IMPORTANT RECALL INFORMATION #40903

**SUBJECT: RECALL CAMPAIGN #40903
Boulder Diesel Rear Tail Light Wiring**

Recall Bulletin #40903

The purpose of this Bulletin is to inform all Fleetwood dealers about a wiring correction for the Bounder Diesel Tail-Stop-Turn light sockets.

Figure 1

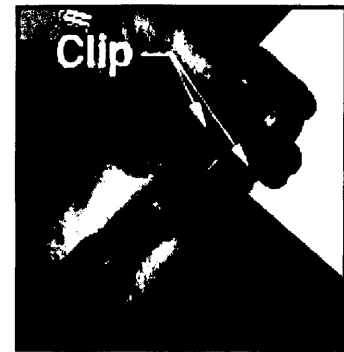
9. Disassemble the two halves of the bulb socket by opening the clips on each side. See Figure 1.
10. Carefully lift the bulb contact terminal attached to the brown wire and free it from the back of the bulb socket. Use a finely pointed instrument like a 12 Volt test light probe or dental pick to perform this operation.

Figure 4

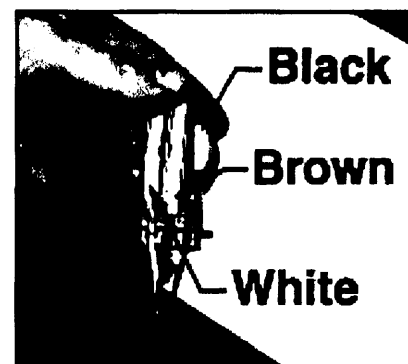
11. Use the same procedure to remove the bulb contact terminal attached to the white wire. See Figure 2.
12. Switch the position of the two bulb contact terminals and reinstall into the back of the bulb socket. The bulb contact terminal connected to the brown wire should now be located in the center of the three socket wires and the bulb contact terminal connected to the white wire should now be located opposite the black wire. See Figures 3 and 4. **Note: The black wire bulb contact terminal will not be moved.**

Figure 5

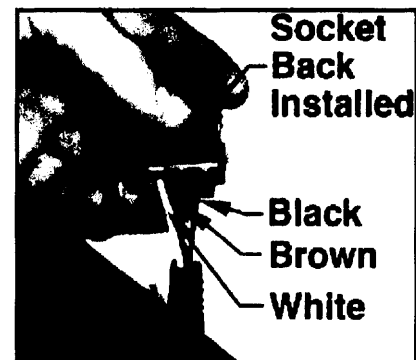
13. Reassemble the two halves of the bulb socket and secure by reconnecting the clips on each side. See Figure 5.
14. Reinstall the bulb into the bulb socket.
15. Follow Steps 5 – 12 for the other taillight assembly.
